SERVICE BULLETIN

Original Issue Date: **2/00**
 Model: **450-2000 kW (Detroit Diesel Series 2000 and 4000 Engines)**
 Market: **Industrial**
 Subject: **Drive Disc-to-Flywheel Bolt Torque Specifications**

Figure 1 Generator Set Component Reassembly (450-1000 kW Model Shown)

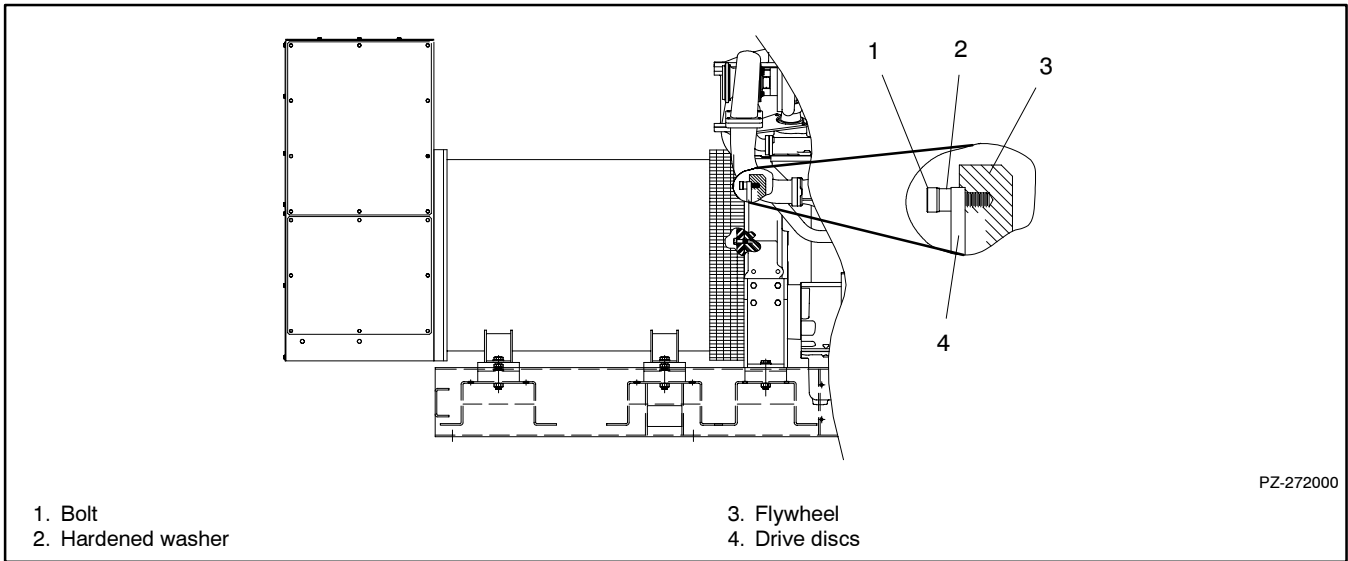
To prevent possible component failure assemble using *new* drive disc-to-flywheel mounting hardware and torque the bolts to 230 Nm (170 ft. lbs.). See Figure 1. The generator set manufacturer recommends using new 5/8-11, grade 8 bolts and hardened washers during reassembly. Refer to Figure 2 for mounting

hardware part number, quantity, and description for each generator set model and generator type.
